PCN#	PCN20250806-010	PCN ISSUE DATE	Aug 6, 2025
PCN TITLE SKU#110061162, Grove Beginner Kit for Arduino			
REVISION		CUSTOMER CONTACT	
TYPE OF CHANGE			
<input checked="" type="checkbox"/> Electrical Specification		<input type="checkbox"/> Part Number	
<input type="checkbox"/> Mechanical Specification		<input type="checkbox"/> End of Life	
<input type="checkbox"/> Firmware Specification		<input type="checkbox"/> Other	
<input type="checkbox"/> Regulatory or Compliance			
AFFECTED PART NUMBER(S)			
Part Number	Name		
110061162	Grove Beginner Kit for Arduino		
CHANGE DESCRIPTION The barometric sensor module update: From BMP280 to SPA06-003.			
Change FROM:			
Part Number	Name	Image	
110061162	Grove Beginner Kit for Arduino

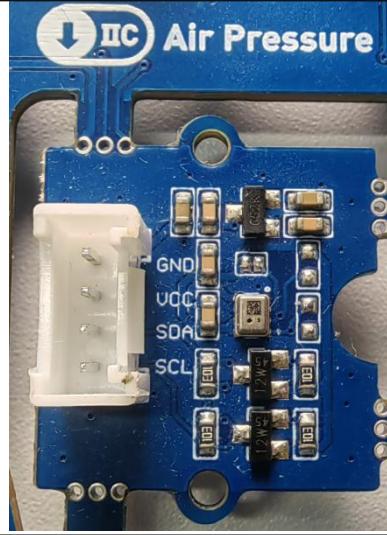
Change TO:		
Part Number	Name	Image
110061162	Grove Beginner Kit for Arduino	
REASONS FOR CHANGE		
The barometric pressure sensor (BMP280) has been discontinued by the manufacturer. To ensure continued supply, it will be replaced with the SPA06-003 sensor , which offers identical core specifications and mechanical compatibility, while delivering enhanced measurement accuracy.		
CUSTOMER ACTION REQUIRED		
Please switch to the alternative product and update any related documentation to ensure compatibility.
